RENESAS TECHNICAL UPDATE

Product Category	MPU/MCU		Document No.	TN-RZ*-A€í A/E	Rev.	1.00
Title	RZ/A1L Groups: Notes about specification defferencies between new version and old version of RZ/A1L.		Information Category	Technical Notification		
Applicable Product	See following	Lot No.	Reference Document	RZ/A1L Group User's Manual: Hardware Rev 1.00 (R01UH0437EJ0100)		
		All

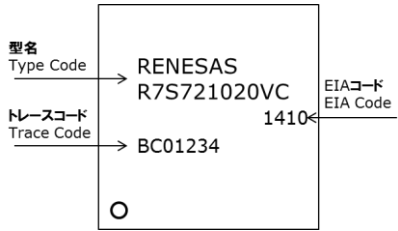
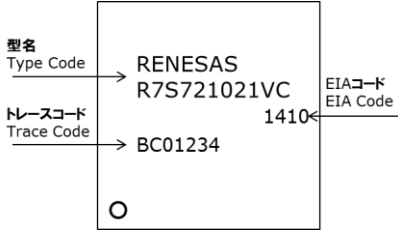
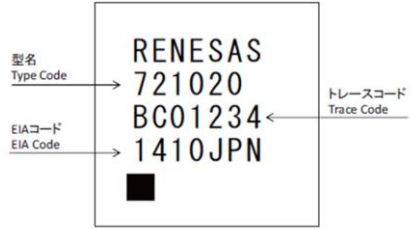
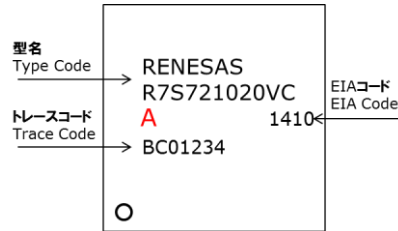
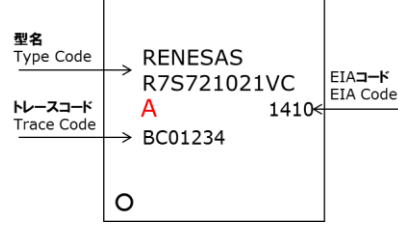
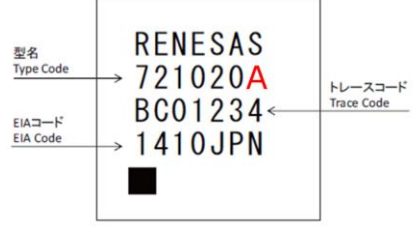
The differences between current product (old version) and revised product (new version) of RZ/A1L is shown below. It is possible to distinguish between current product and revised product in the difference of the mark. There is no functional difference other than restriction on power on sequence, so current product and revised product is software compatible. For more information about detail function differences, please see “3. Detail function differences”.

Current Product	Revised Product
Part Name	R7S721020VLFP, R7S721020VCFP, R7S721020VCBG, R7S721021VLFP, R7S721021VCFP,	Same as Current Product
function	There is one restriction on power on sequence. Because there is difference in specification described in the user’s manual in this point, it may be necessary to take countermeasure described in “3. Detail function differences” depending on system requirement.	No restriction on power on sequence, as described in the user’s manual.
Physical Outline	—	Same as Current Product
Mark	Nothing is marked between Type Code and Trace Code. QFP176  QFP208  BGA176 	“A” is marked between Type Code and Trace Code. QFP176  QFP208  BGA176

3.3V is turned on before 1.2V is turned on

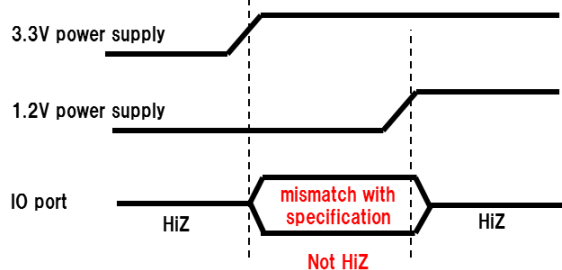
State of input-output terminal is possibly mismatch with specification (HiZ) until 1.2V power on, even if the TRST and RES pins are driven to low.

* Even if the TRST and RES pins are driven to LOW.

- In power on sequence, turn 1.2V power on before or simultaneously to 3.3V power on.

3.3V is turned on before 1.2V is turned on

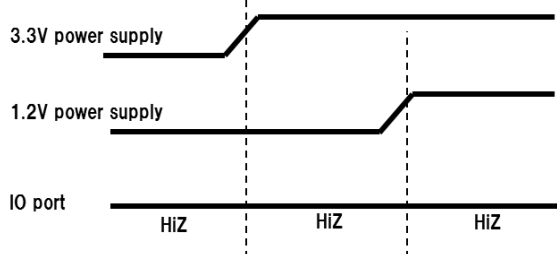
Restriction described in “3.1 Restriction for current product” is relaxed in revised product.

Regarding the input/output state, following timing chart shows input/output state under the condition that the TRST and RES pins are driven to low.

* Under the condition that the TRST and RES pins are driven to LOW.
